SEL-79-05

REVISION TRANSMITTAL

OIL - O-RING INSPECTION AND INSTALLATION FOR OIL PRESSURE TRANSDUCER

Figure 1. Oil Pressure Transducer Installation (Sheet 1)

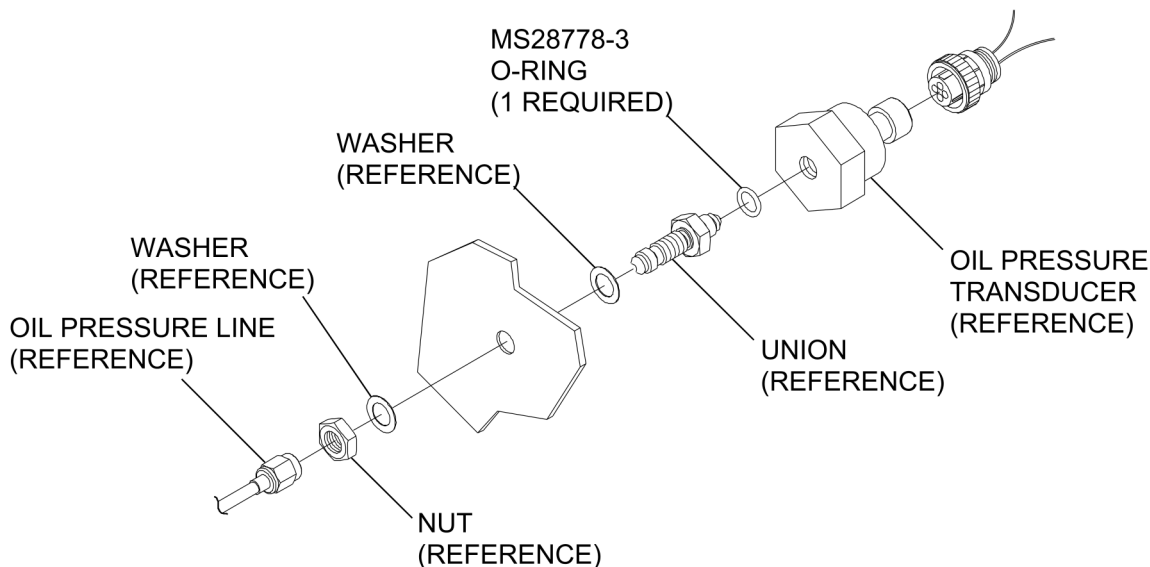
- A. Changes the Compliance from Recommended to Mandatory.
- B. Changes the orientation and location of the union on the illustration.
